Subject: Submittal of Additional Information Concerning Remediation Activities at the
Westinghouse, Waltz Mill Site, Madison, Pennsylvania
License No., SNM-770, Docket No. 07000698

**Response to NRC Letter Dated August 10, 2001
Request for Additional Information
Concerning Remediation Activities**

**Waltz Mill Site
Madison, Pennsylvania**

**Response to NRC Letter Dated August 10, 2001
Westinghouse Electric Company, LLC
Request for Additional Information
Concerning Remediation Activities at the
Westinghouse Waltz Mill Site
Madison, Pennsylvania**

FIGURE E-1
 CROP LINE AND MINED-OUT AREAS
 OF THE UPPER FREEPORT COAL
 WALTZ MILL SITE
 MADISON, PENNSYLVANIA

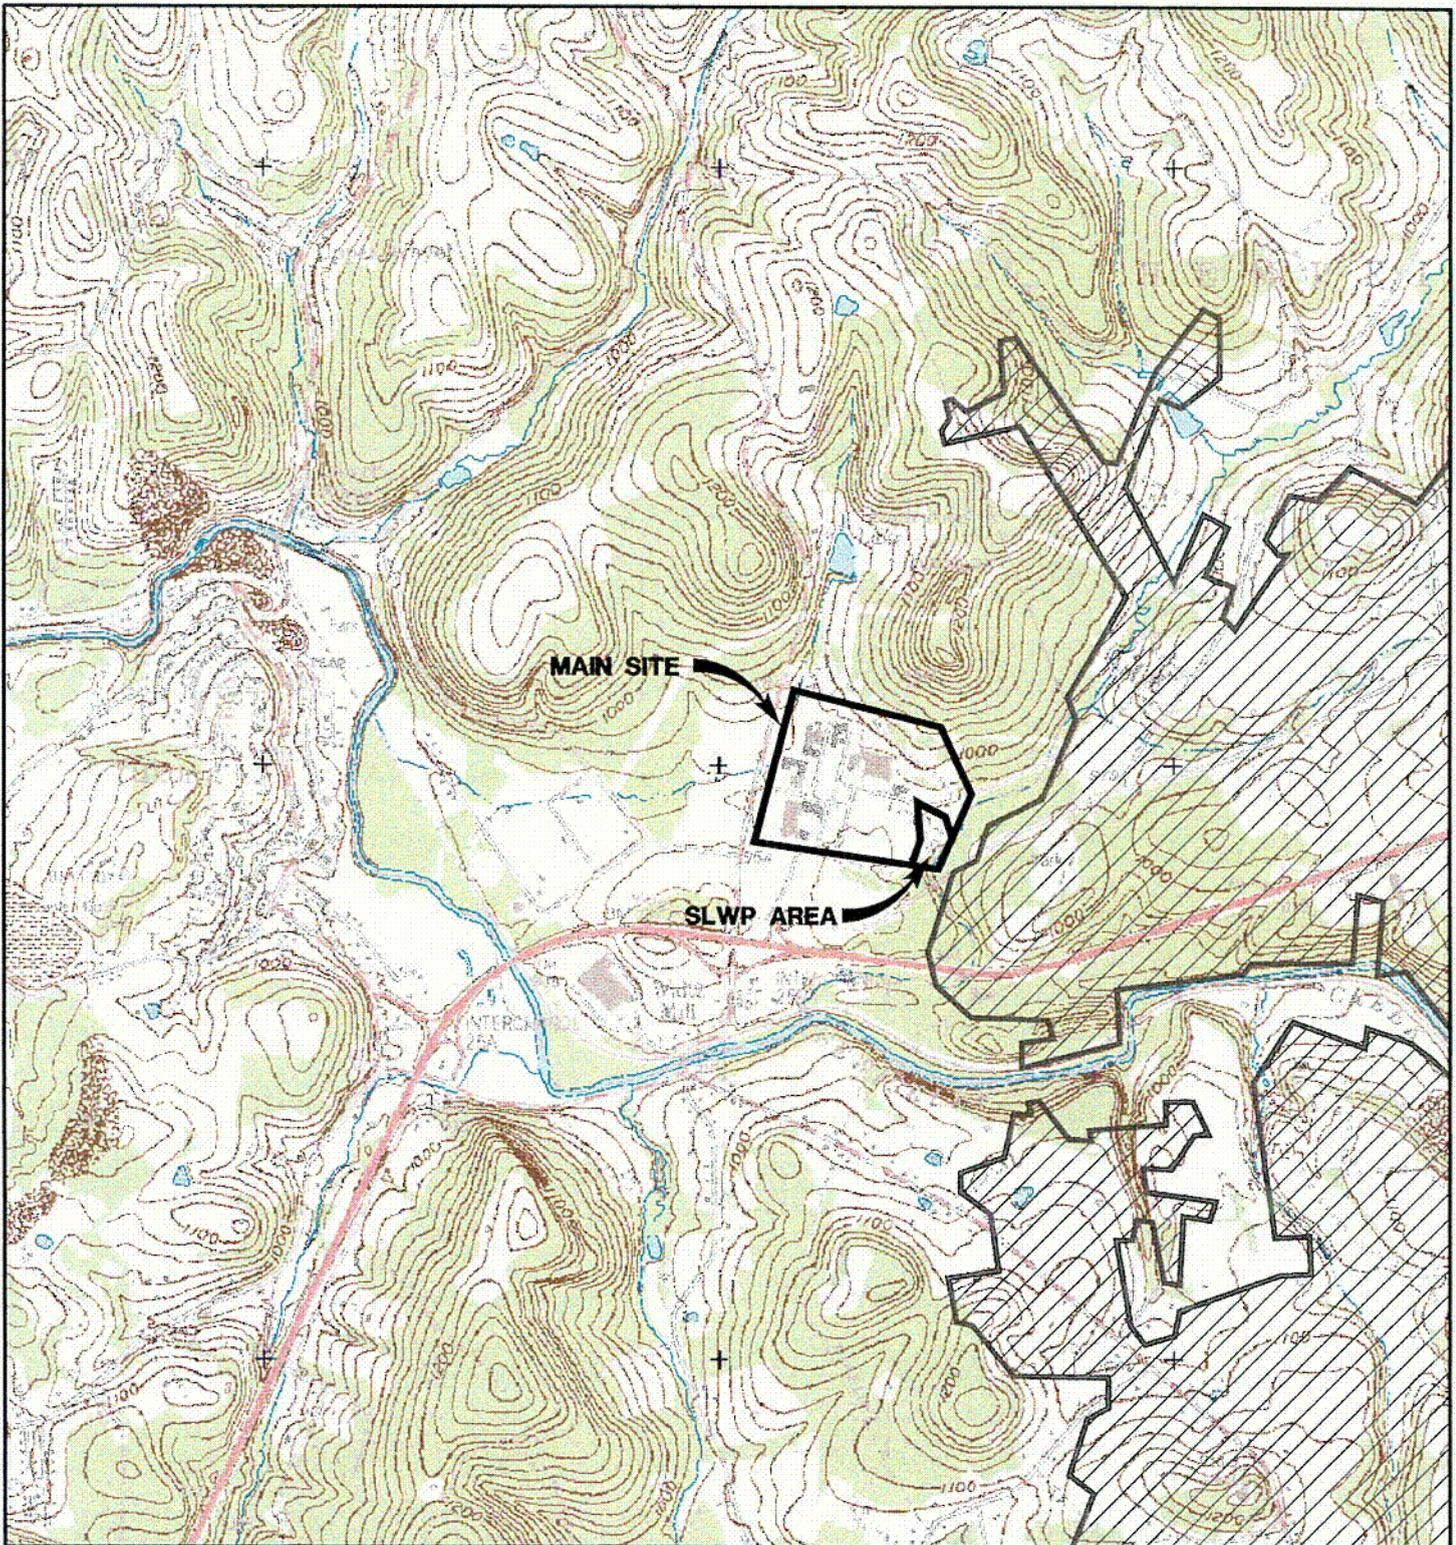
Question No. 6: Underground coal mining east of the site has the potential to cause land subsidence and groundwater redirection/diversion. Have you identified the presence of any actual mines beneath the site, and if present, what potential impact do they have on groundwater?

Response: Attachment E contains information on subsurface mining activities within the vicinity of the Waltz Mill Site. Attachment E includes a U.S. Geological Survey (USGS) quadrangle map showing the coal crop lines and structure contours of the coal seams beneath the site. A similar map illustrates mined-out areas of the Upper Freeport Coal, which is the shallowest coal seam present beneath the study area. These maps indicate that the Upper Freeport Coal is approximately 115 feet (Calley's Run area) to 150 feet (former LWRB area) below ground surface. The structural dip of the coal seam is to the west at about 185 feet per mile or 2 degrees. Because of the changes in topography over the site and the dip of the coal, the Upper Freeport Coal is approximately 200 feet below ground surface within the former test reactor area.

Mined-out areas of the Upper Freeport Coal are not located directly beneath the SLWP area. As illustrated in the attached USGS map, deep mining of the Upper Freeport Coal has occurred east of this area and just east of Calley's Run. There is no field indication of subsidence nor is it expected to any great degree in the SLWP area, based on the relative depth and distance of the mined-out areas from the SLWP area. Deep-mining operations can result in increased fracturing of overlying bedrock units resulting in a dewatering of the overlying water-bearing zones. The presence of a continuous water-bearing zone beneath the SLWP area indicates that dewatering of this monitored zone is not occurring, which again is expected based on the depth and distance of the mined-out areas. In conclusion, deep mining has not occurred beneath the SLWP area and the data do not indicate that adjacent mining activities have had an effect on groundwater flow directions.
